UNITED STATES PATENT AND TRADEMARK OFFICE

APPLICATION NO.	FILING DATE	FIRST NAMED INVENTOR	ATTORNEY DOCKET NO.	CONFIRMATION NO.
10/583,793	03/12/2007	Markus Kley	WW053USU	8546

Office Action Summary	Application No. 10/583,793	Applicant(s) KLEY, MARKUS	
	Examiner Thai-Ba Trieu	Art Unit 3748

DETAILED ACTION

Fig.1

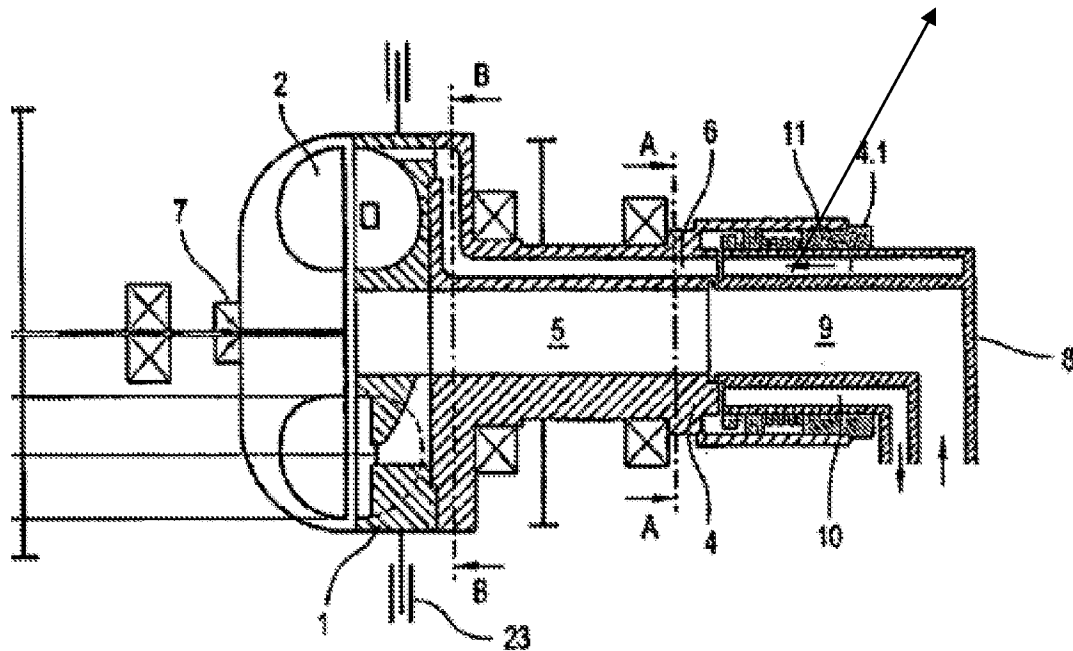
4. The arrow in the Fig. 1 should be shown as indicated below, since the channel 10 for working medium in flow conducting manner with the evacuation channel (6) for discharging the working medium out of the toroidal working chamber.

The arrow should be changed in
the direction as
